Historical Areas Board of Review(HABR)

PROPERTY ADDRESS: 17 Kopac Lane, Palisades, NY Section/Block/Lot: 78.13-1-3.9

Project Name: Tramutola Residence

Amendment to HABR # 22-17 dated July 12, 2022

GENERAC®

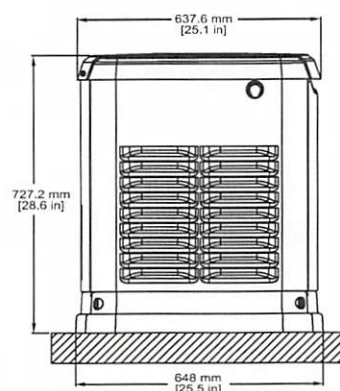
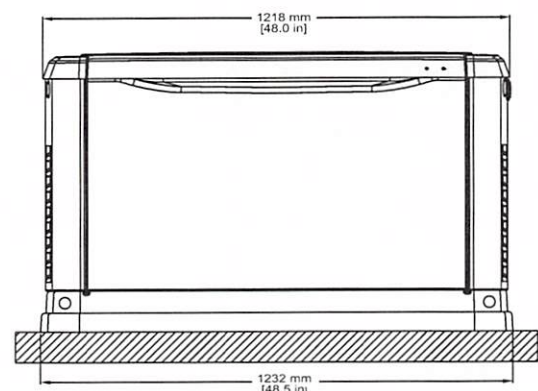
15. The A/C Condenser units are to be located on the right side (north) and screened with plantings/shrubs.
16. The Generac Guardian 26KW generator will be located on the north side of the house, as shown on the hardscape plan. Plantings will be held back the distance recommended by the manufacturer.

PROJECT
PROPOSED PATIO FOR
TRAMUTOLA RESIDENCE
17 KOPAC LANE
TOWN OF ORANGETOWN
ROCKLAND COUNTY, NEW YORK

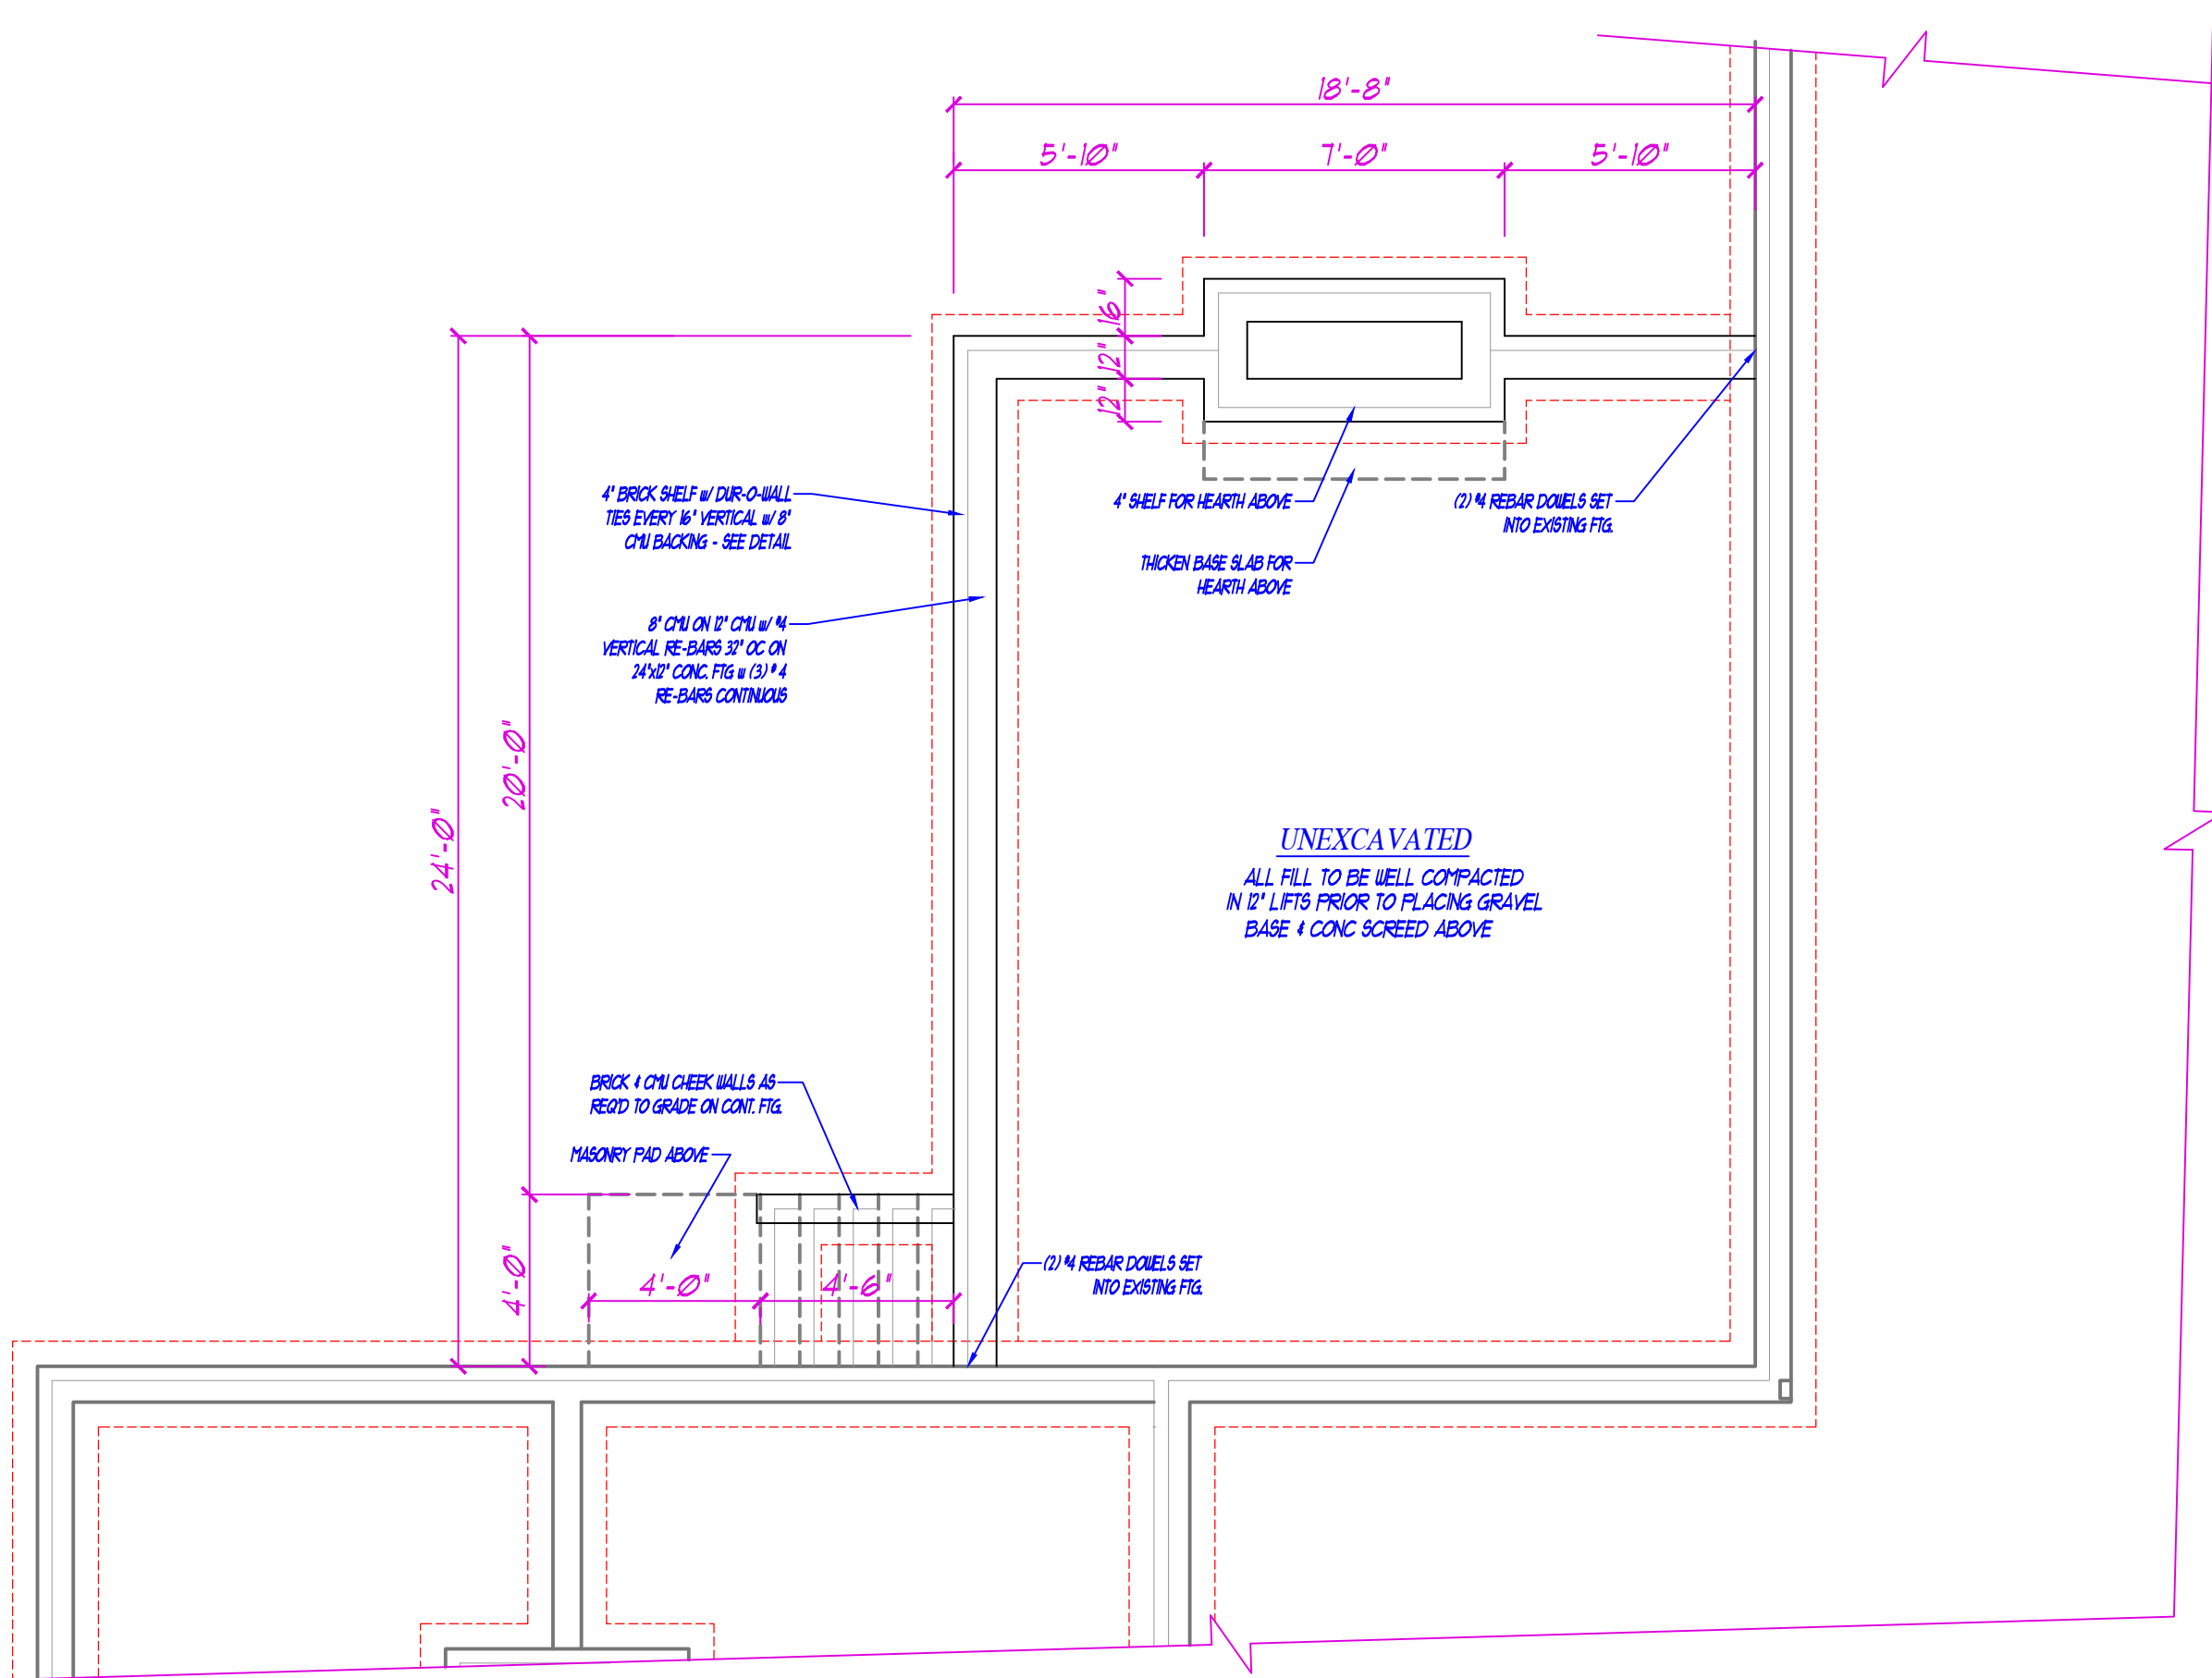
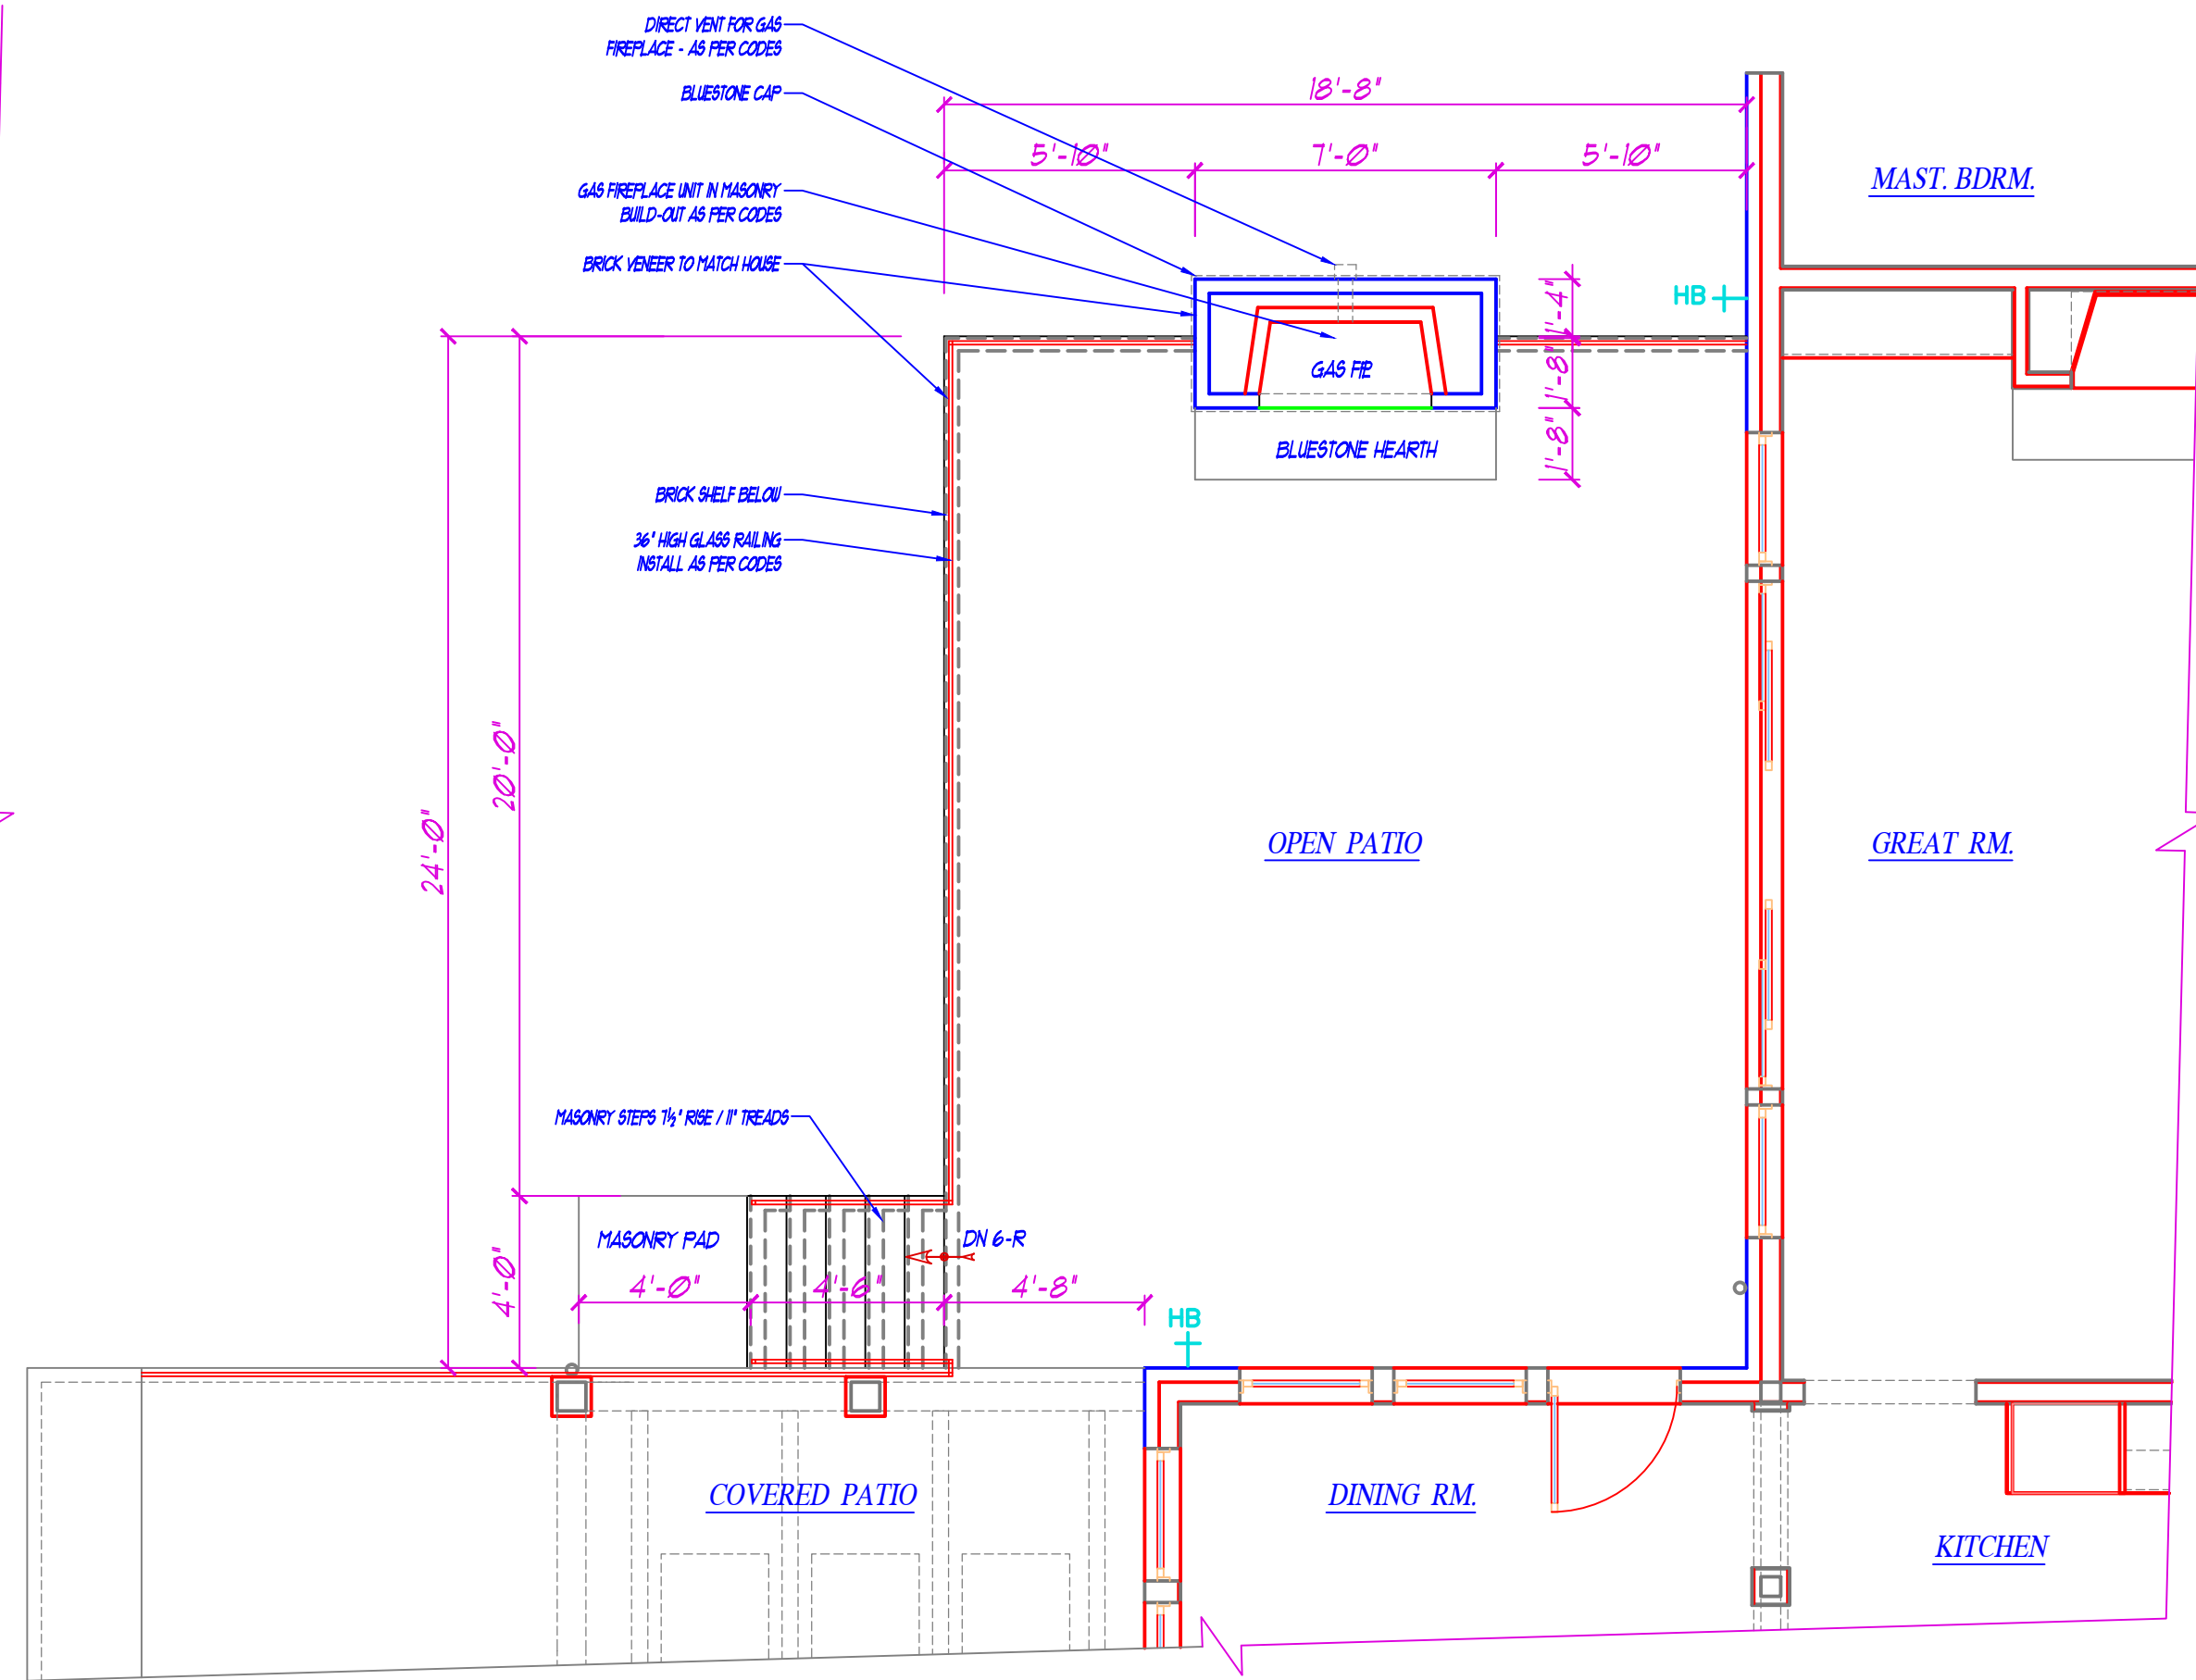
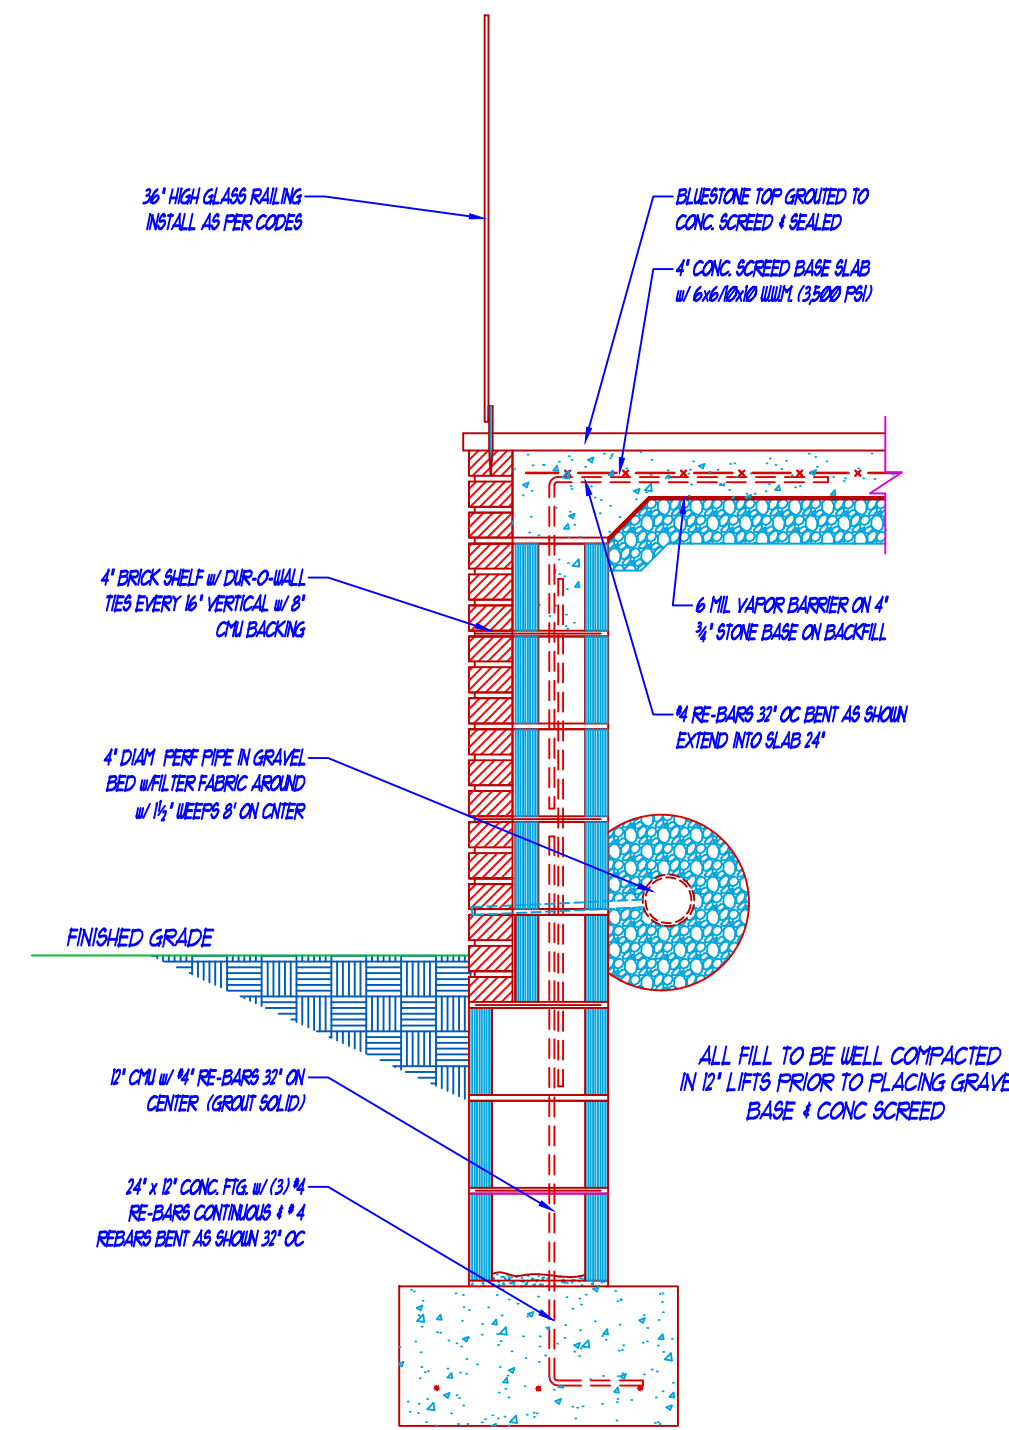
12. The Rear patio to be built with concrete & brick Cambridge® Sigma split face wall blocks and the patio surface to be bluestone Cambridge LedgeStone 3-pc paver. The color for both is Toffee/Onyx. The patio face will now be the same brick as the house, and the patio surface is bluestone flagging. As indicated in #1 above, a gas fireplace with a brick exterior will be built on the perpendicular north side of this patio. A fireplace design example picture is provided.
